Name Of Dam: —TIMBER LAKE DAM  
Location: FAIRFAX COUNTY  
Inventory Number: VA. 05918

# PHASE I INSPECTION REPORT

TIMBER LAKE DAM  
FAIRFAX COUNTY, VIRGINIA  
INVENTORY NO. VA 05918

Name of Dam: Timber Lake Dam  
State: Virginia  
County: Fairfax  
USGS Quad Sheet: Vienna, Virginia  
Stream: South Fork Run  
Date of Inspection: May 29, 1979

SKETCH OF PLAN VIEW  
FOR  
TIMBER LAKE DAM

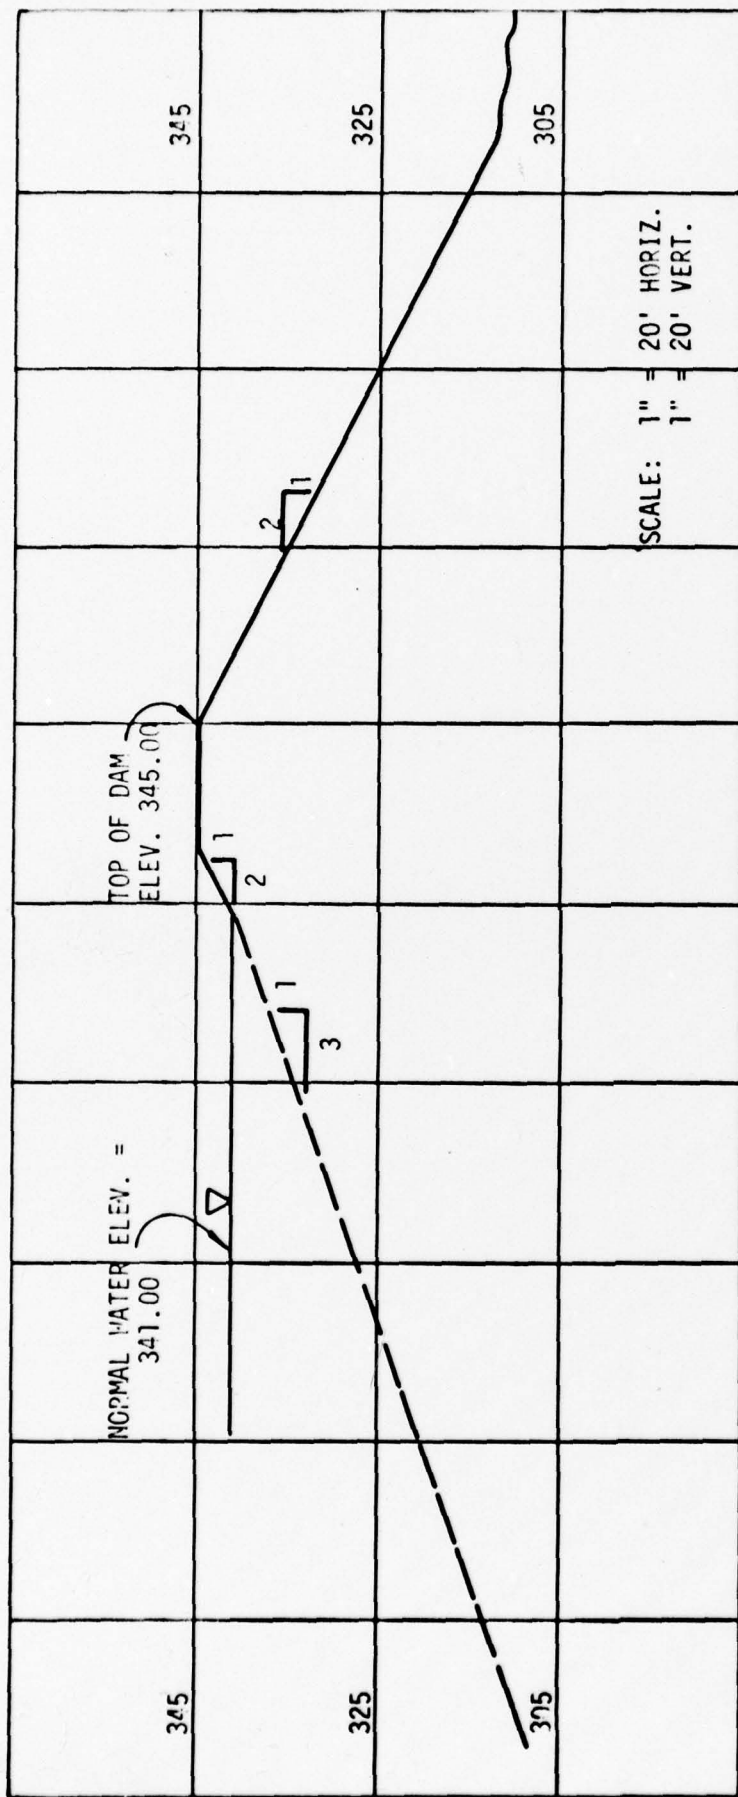
Timber Lake Dam is located in the County of Fairfax west of Vienna. The dam is one half mile north of State Route 627 about 3 miles east of Vale, Virginia. The dam is an earth embankment about 400 feet in length. The dam is 30 feet high from the crest of the embankment to the streambed at the downstream toe of the dam. The top of the dam is 12 feet wide. The dam is classified as small size and significant hazard. The dam is owned by Mr. Joe Young. The purpose of the dam is for recreation i.e. swimming, boating and picnicking. The principal spillway consists of a drop inlet with three sides open connecting to two 24-inch pipes extending through the embankment. There is an emergency spillway located to the left of the dam. This spillway consists of a 150 foot wide grass section with an elevation approximately 6-inches lower than the crest of the dam (see Plate 1, Appendix I.)

The principal spillway is a drop inlet with three open sides connecting to two 24-inch concrete pipes extending through the embankment. There is an emergency spillway located to the left of the dam. This spillway consists of a 150-foot wide grass section with an elevation approximately 6 inches lower than the crest of the dam (see Plate I, Appendix I). Drawdown for the reservoir is accomplished by the use of a siphon.

2.3 Operation: In 1972, as a result of heavy rain and flooding, the emergency spillway to the left of the dam was eroded. The emergency spillway was repaired shortly after the flood and the drop inlet (principal spillway) and two 24-inch diameter pipes were installed (see Plate 1, Appendix I.)

An emergency spillway is located to the left of the dam. This spillway is approximately 150 feet wide with an elevation 6 inches lower than the crest of the dam (see Plate 1, Appendix I). The spillway is covered with grass, except along the shoreline where sand has been placed for use as a beach.
